ISSUE: Certificate of Appropriateness for alterations

APPLICANT: Mary Denby with MHD Builds

LOCATION: Old and Historic Alexandria District
201 Gibbon Street

Figure 1: Proposed modifications to 201 Gibbon Street

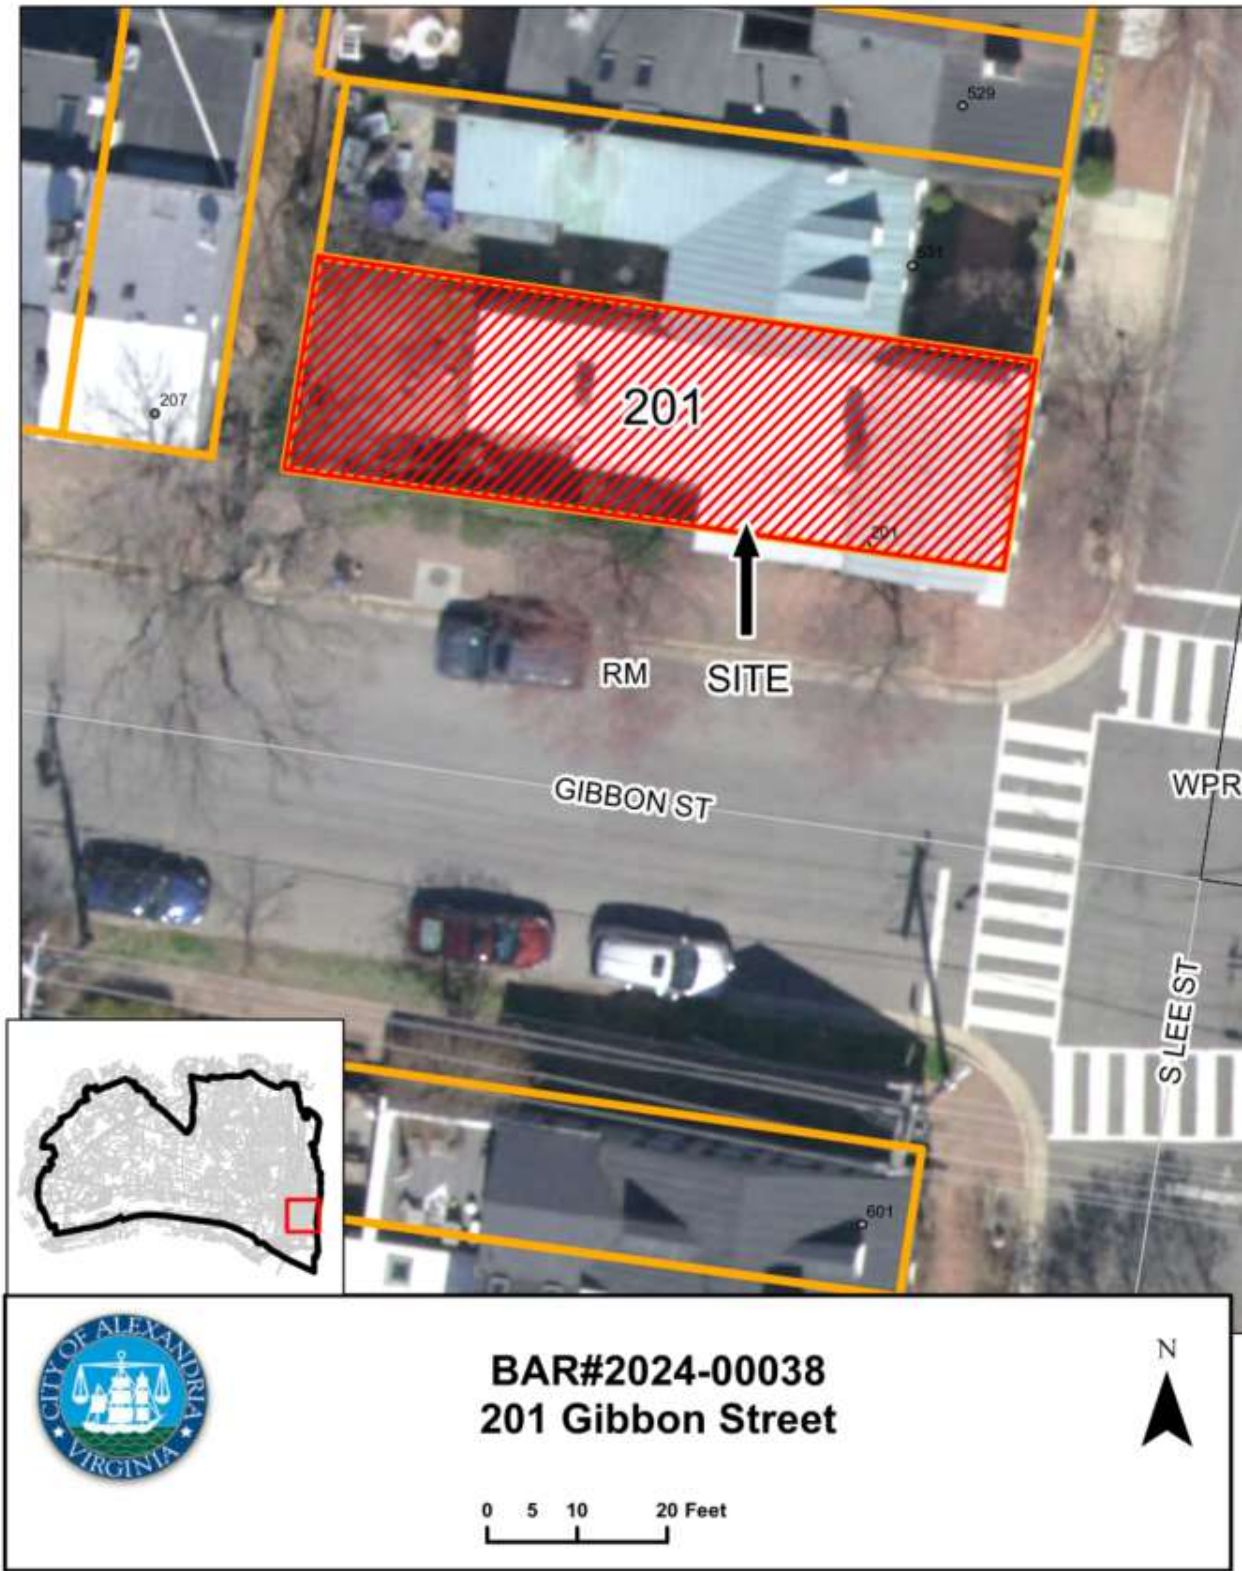
The applicant requests a Certificate of Appropriateness to replace two second floor windows and remove an existing masonry chimney (Figure 1).

In response to an application for administrative approval to replace existing windows, staff visited the property on January 31, 2024. During this visit staff found that the ground floor windows adjacent to the subject windows were not original to the structure and could be replaced with appropriate windows. This approval was granted as part of BAR 2024-00019. At this site visit, staff noted that the second-floor windows appeared to be older than the ground floor windows and featured cylinder glass that would be consistent with the age of the structure. Staff also noted that while the windows are painted shut and require some repair, their condition is such that repair is reasonably possible and that they can be retained. Following the guidance of the *BAR Policies for Administrative Approval*, the replacement of these windows has been removed from the administrative review application and is before the Board. Staff finds that consistent with the *Design Guidelines*, the existing windows are original and should be retained in place and recommends denial of a Certificate of Appropriateness for their replacement.

The *Design Guidelines* say that “Chimneys and flues are important functional elements of a building and provide visual variety to the roofline. At the same time, chimneys and flues can have an important impact on the overall visual composition of a building and, if not appropriately located on a building, may be a visual disruption of a unified building design.” They further say that “Existing chimneys should be maintained in situ and not removed without a compelling reason and substantial justification.” As noted in the submission materials, the chimney proposed to be removed was originally constructed in the 1950’s and was built differently than shown in the approved documents. The existing chimney is not expressed on the exterior wall and is visible only as it penetrates the roof. The masonry construction is not of unique design or material and the location on the roof actually detracts from the overall building composition, becoming a “visual disruption”. It should be noted that the area of demolition is less than twenty five square feet, therefore the removal of the chimney does not require a separate Permit to Demolish. Because of the later construction and the overall building composition, staff recommends that the Board approve the Certificate of Appropriateness for the removal of the existing chimney.

1. Upon removal of the existing chimney, the roof be patched to match the adjacent roofing.
2. The existing second floor windows be retained in place and repaired as necessary in lieu of being replaced.

EXISTING PHOTOS OF WINDOWS

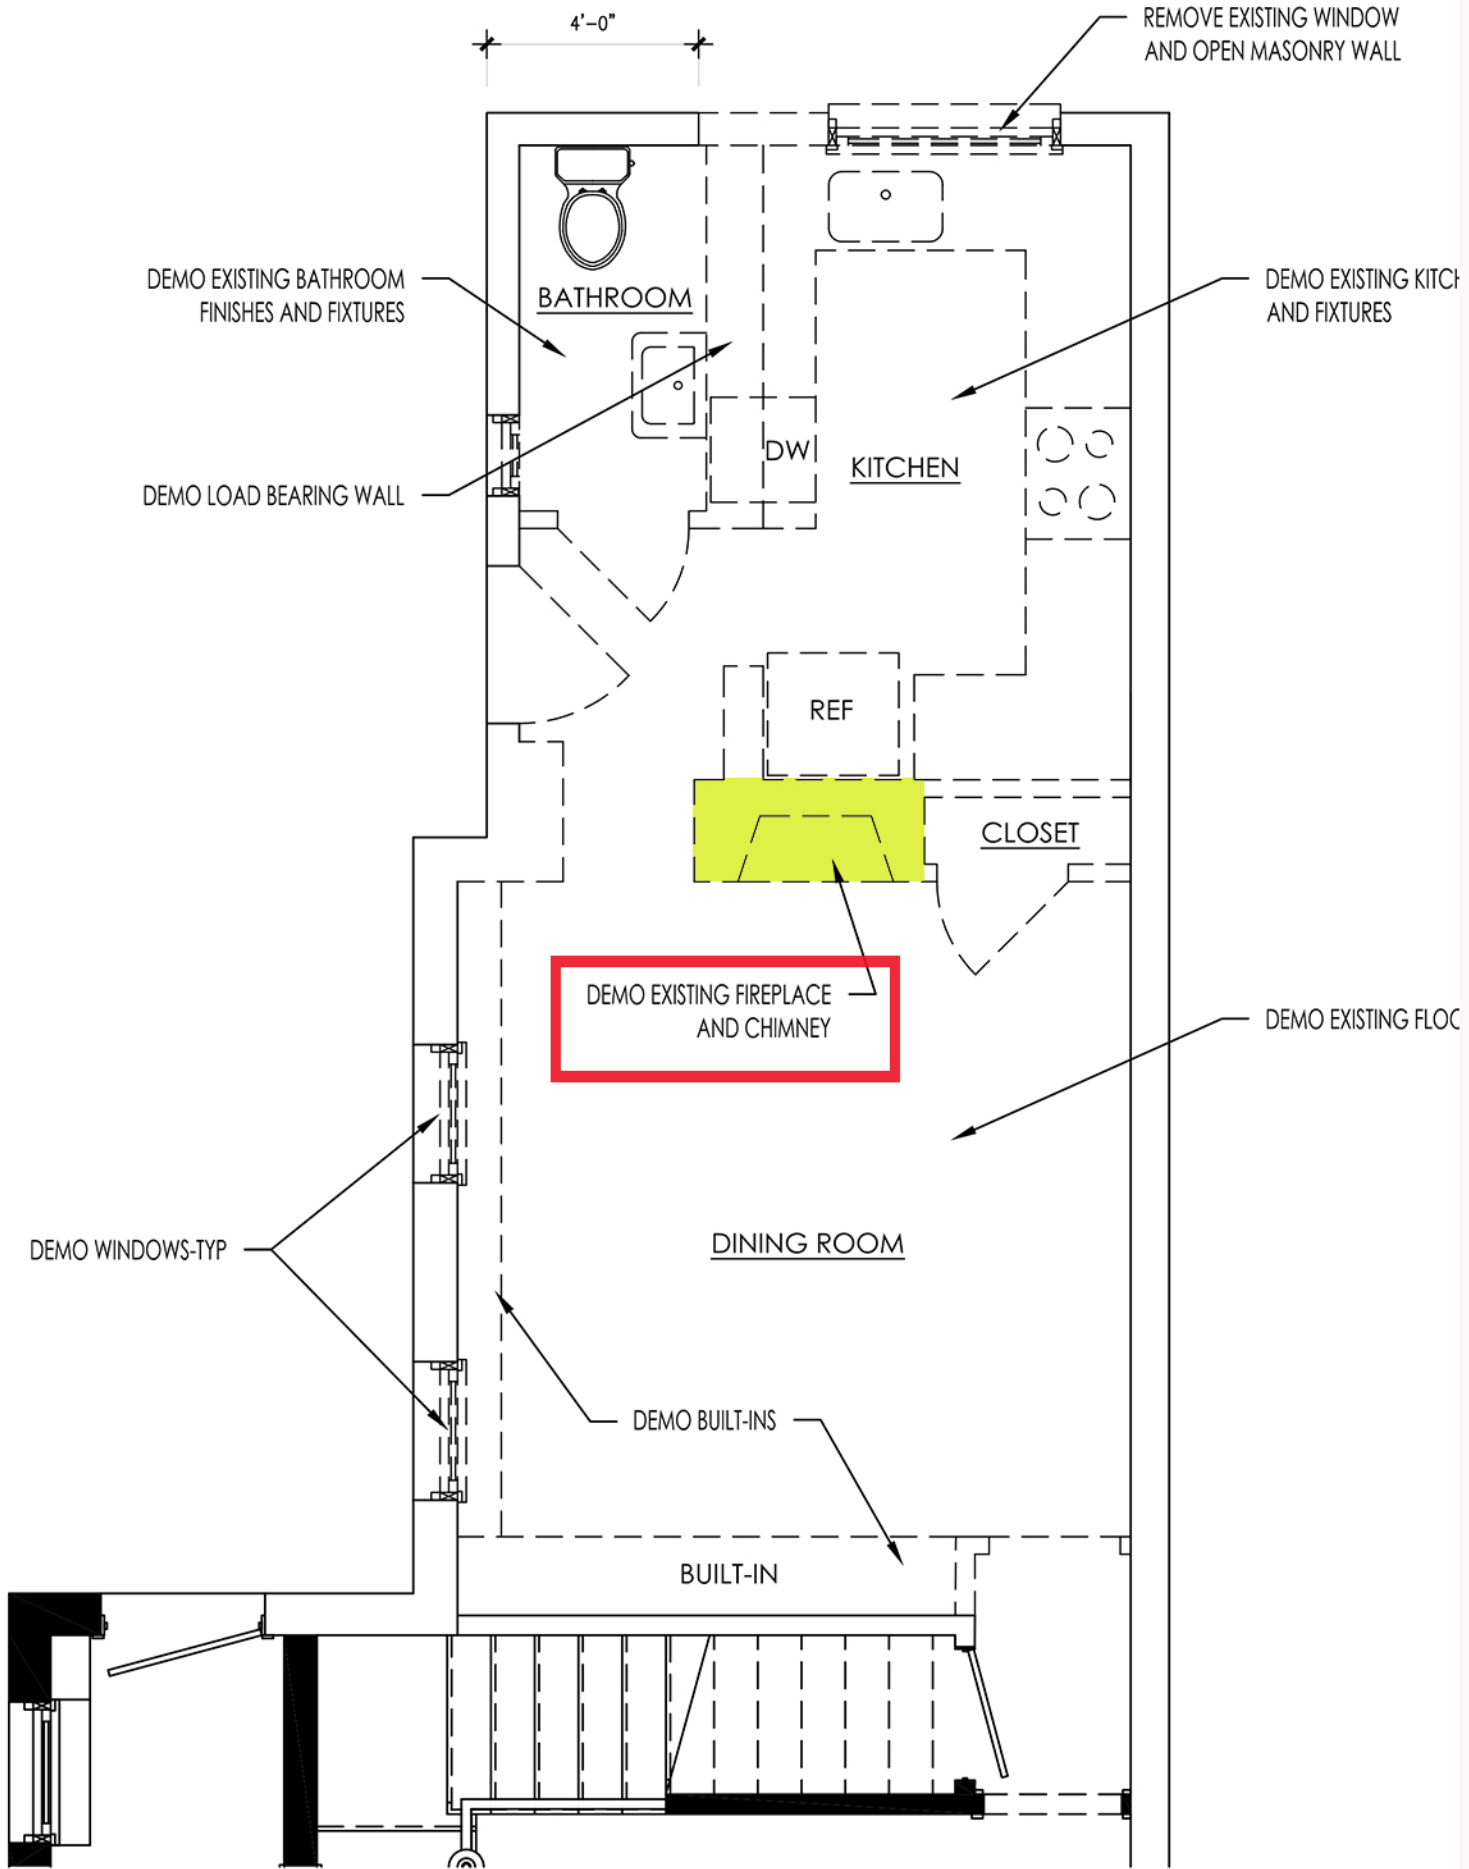
The windows are completely inoperable, are painted shut, and have rotten wood on the exterior.
